Subject: **WATR 2007o – Bunche Park Water Main Replacement Project**
Notice of Change of Conditions

**RE: Notice of Change of Conditions
City of North Miami Beach – Bunche Park Water Main Replacement Project
Project No. 24-016-SG**

We have now quantified the change of conditions to include 6 different changes quantified below.

DATE: 1/18/2024
 DRAWING NO.: PM-5

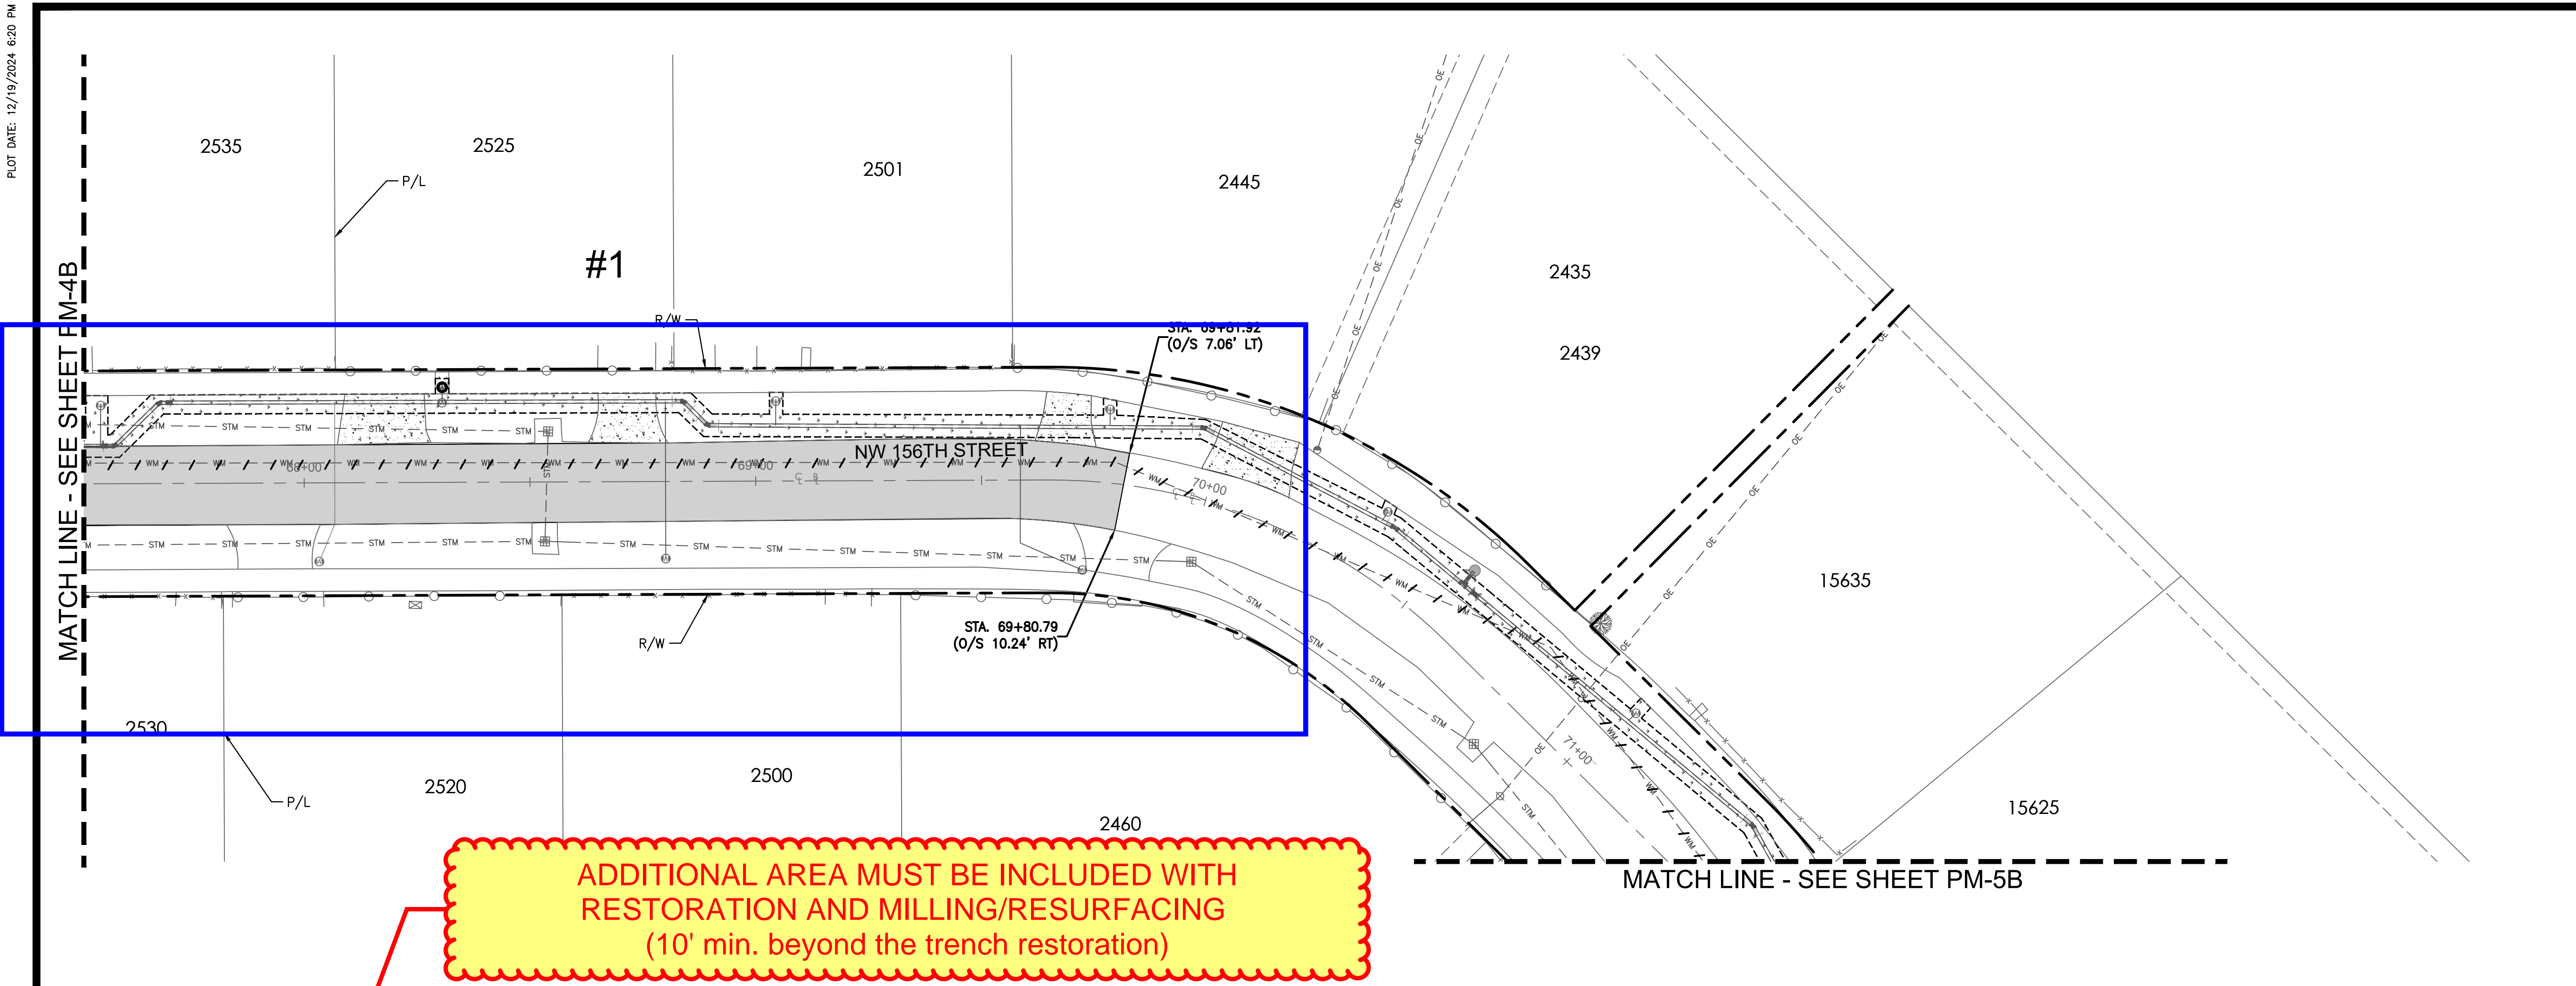
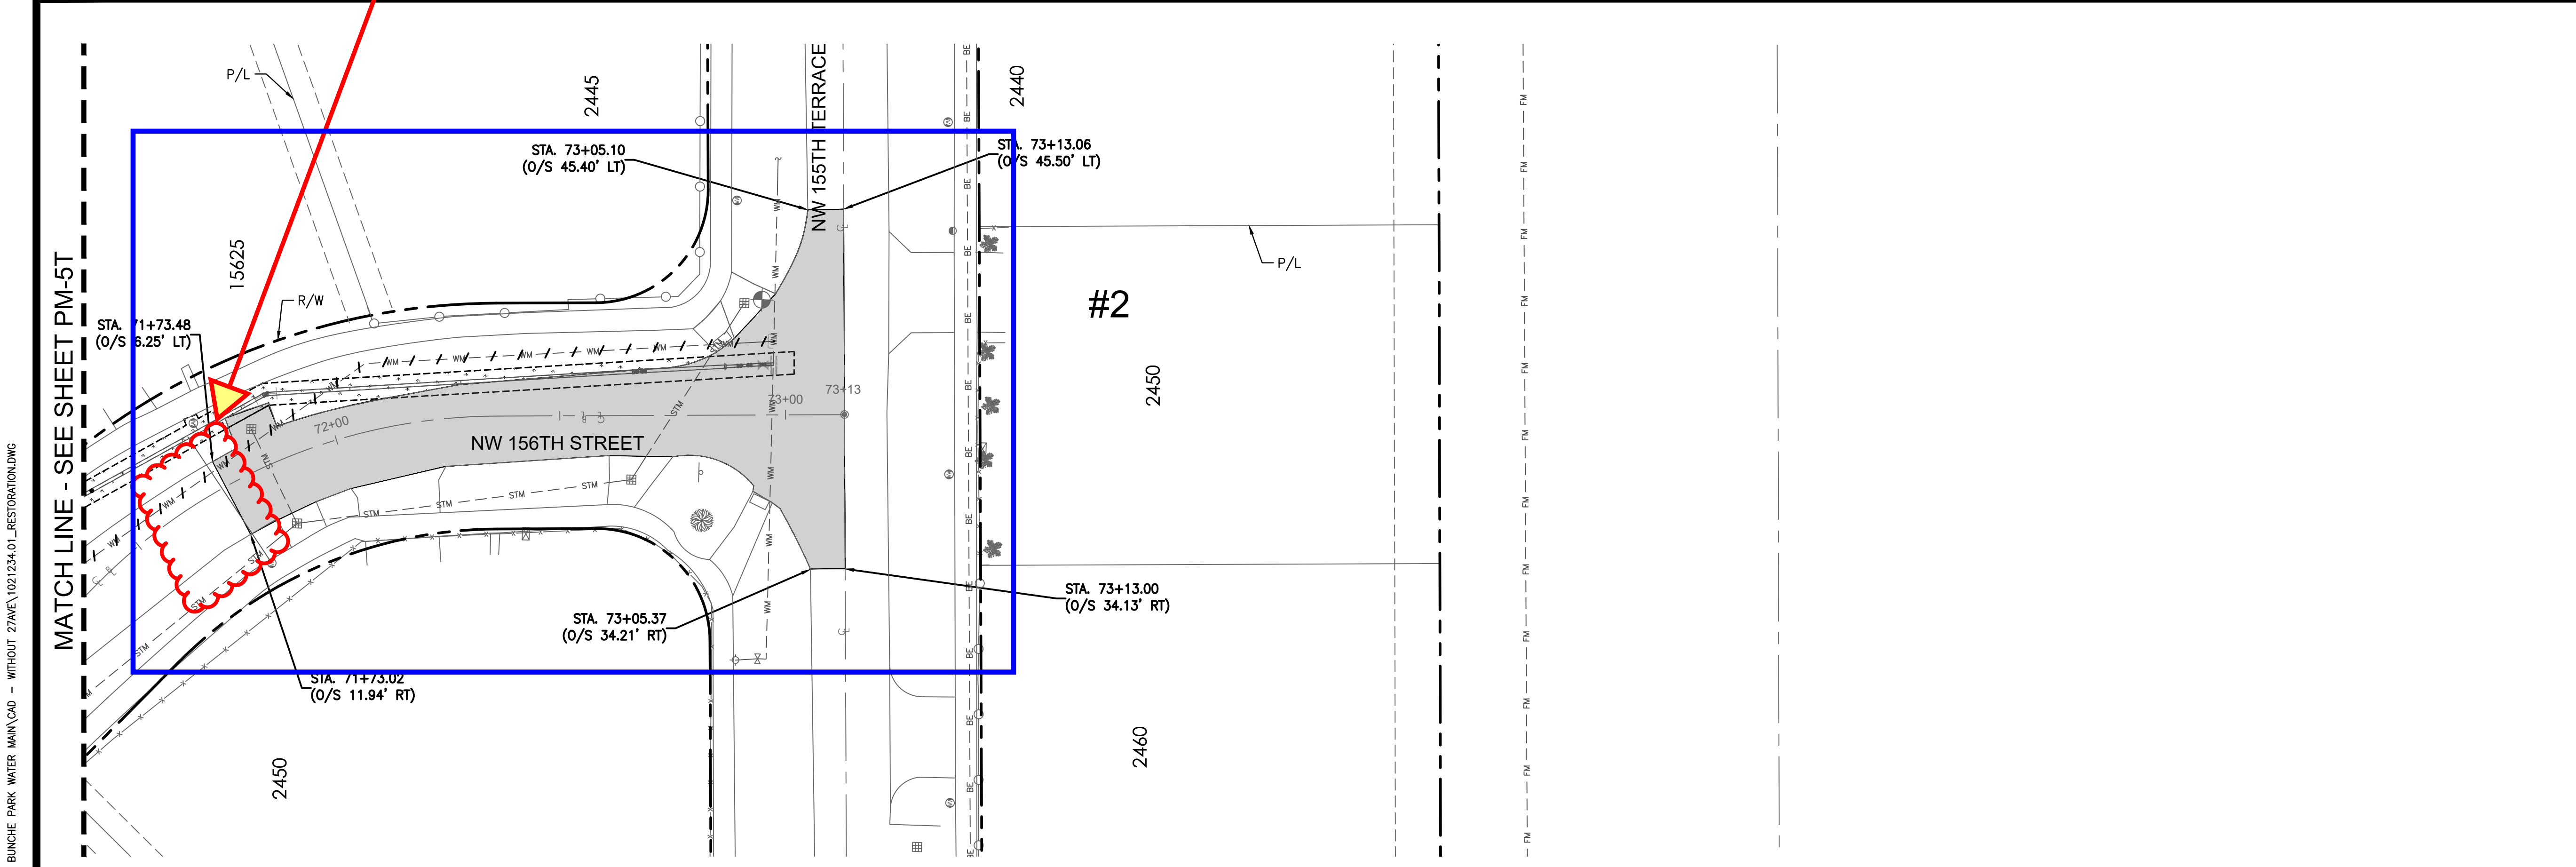
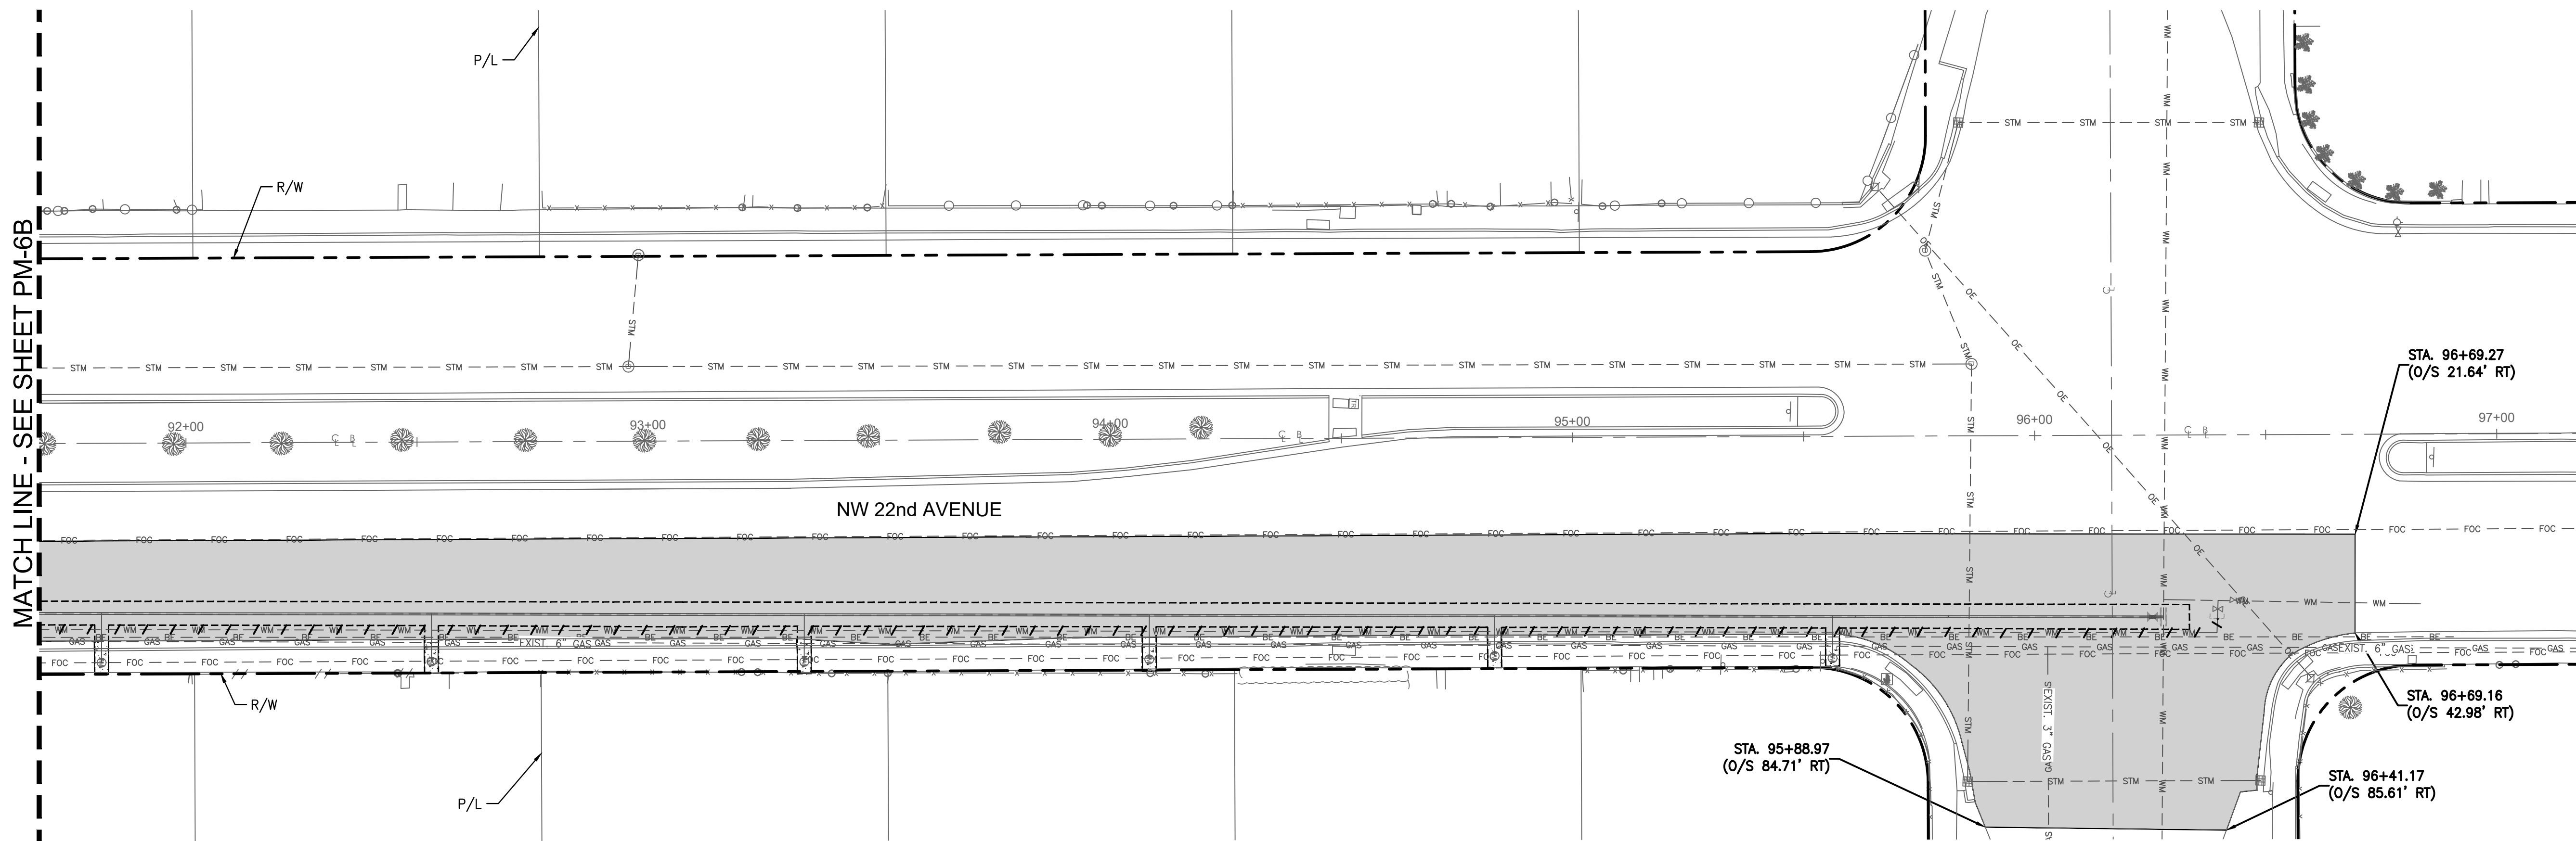
Additional Mill and Overlay Quantities #1									
	Start Station	Stop Station	Page	Total LF	Width	Total SY	Mill \$ (\$3/SY)	Asphalt Overlay (\$14/SY)	Total \$
Bid Spec	64+27	67+61	PM-4 - PM-5	334	10	371.1111111	\$1,113.33	\$5,195.56	\$6,308.89
MG Spec	64+27	69+80	PM-4 - PM-5	553	20	1228.888889	\$3,686.67	\$17,204.44	\$20,891.11
Cost Difference									\$14,582.22

Additional Mill and Overlay Quantities #2									
	Start Station	Stop Station	Page	Total LF	Width	Total SY	Mill \$ (\$3/SY)	Asphalt Overlay (\$14/SY)	Total \$
Bid Spec	72+12	73+13	PM-5	101	10	112.2222222	\$336.67	\$1,571.11	\$1,907.78
MG Spec	71+73	73+13	PM-5	140	20	311.1111111	\$933.33	\$4,355.56	\$5,288.89
Cost Difference									\$3,381.11

DATE: 1/18/2024
 DRAWING NO.: **PM-7**

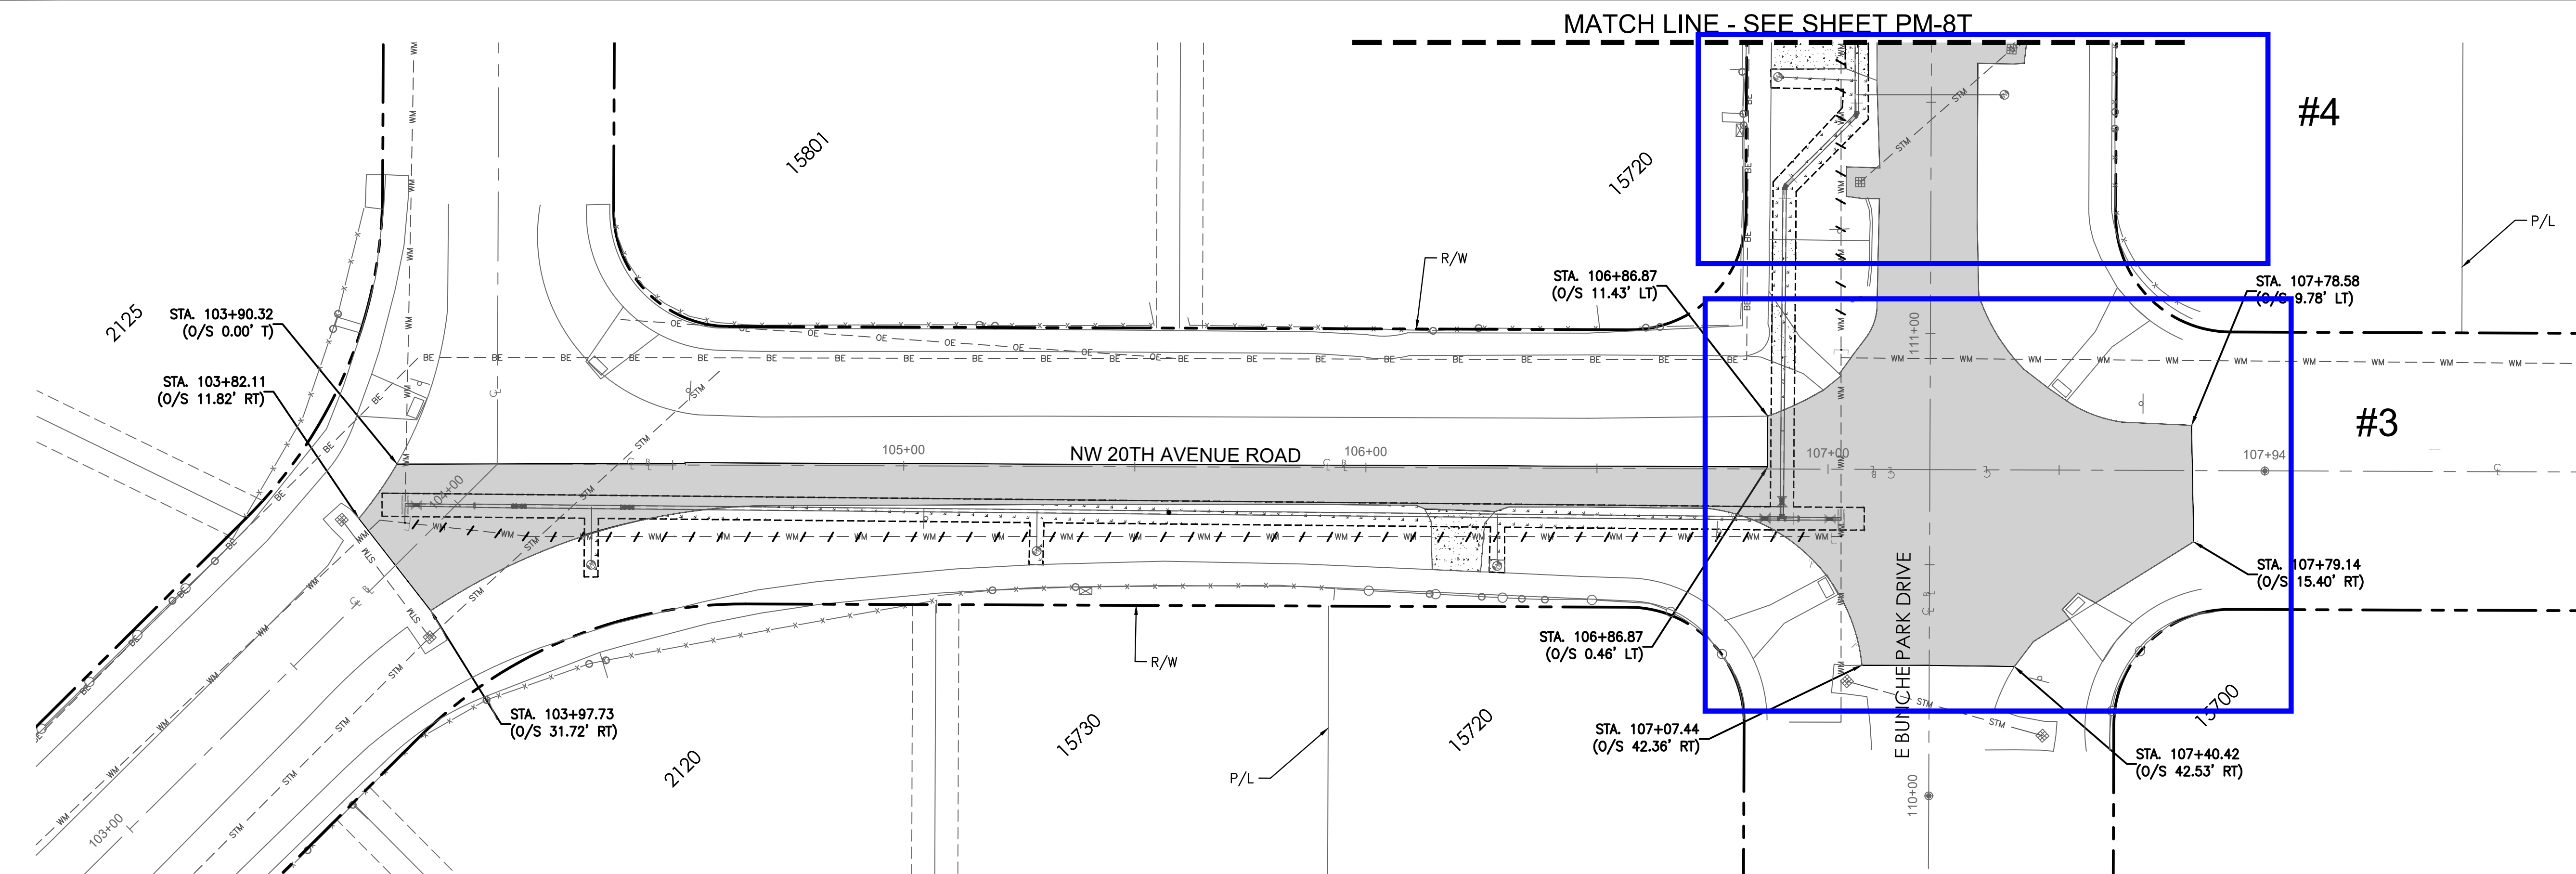
Additional Mill and Overlay Quantities #3									
	Start Station	Stop Station	Page	Total LF	Width	Total SY	Mill \$ (\$3/SY)	Asphalt Overlay (\$14/SY)	Total \$
Bid Spec	106+86	107+22	PM-7	36	10	40	\$120.00	\$560.00	\$680.00
MG Spec	106+86	107+79	PM-7	93	20	206.6666667	\$620.00	\$2,893.33	\$3,513.33
Cost Difference									\$2,833.33

Additional Mill and Overlay Quantities #4									
	Start Station	Stop Station	Page	Total LF	Width	Total SY	Mill \$ (\$3/SY)	Asphalt Overlay (\$14/SY)	Total \$
Bid Spec	111+15	111+15	PM-7	0	0	0	\$0.00	\$0.00	\$0.00
MG Spec	111+15	111+85	PM-7	70	20	155.5555556	\$466.67	\$2,177.78	\$2,644.44
Cost Difference									\$2,644.44
